SLOVENSKI STANDARD
SIST-TP CEN/TR 17842-1:2023

Playground equipment for children - Part 1: Replies to requests for interpretation of EN 1176:2017 and its parts (2018-2019)

CEN/TR 17842-1

Playground equipment for children - Part 1: Replies to requests for interpretation of EN 1176:2017 and its parts (2018-2019)

Figure 3

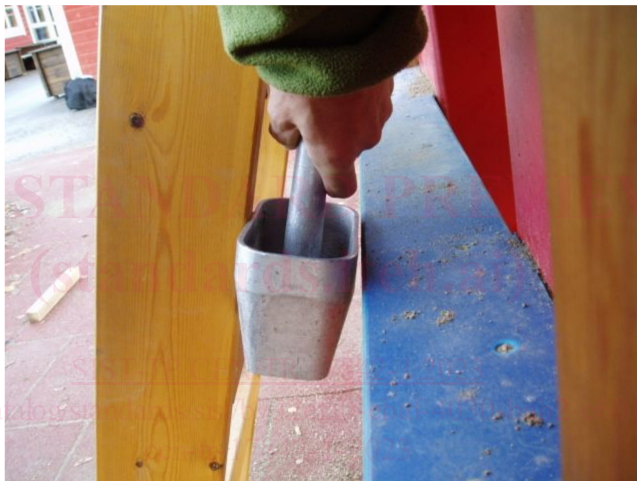
- 1) **Partially bound rigid openings that consist of parallel or close to parallel sides that are between 8,9 to 23 apart – see Figure 3 and Figure 4.**
- 2) **Flexible V-shaped openings with a lower edge above 60 between two flexible sides or one flexible side and one rigid side – see Figure 5.**
- 3) **Partially bound rigid Horizontal opening – in what we here call “arm-walk”.**

1) Opening with parallel sides - between ledge and back side of ladder. A child wanting to pass through the ladder or out the play house can get caught between the step in the ladder - the one just above the blue opposite edge - and the blue edge of the play house. The ledges being paralleled for more than 50 cm gives the child little but no possibility to escape. This is per definition NOT a completely bound opening and not a partially bound opening that deviates from D.2.2 test.
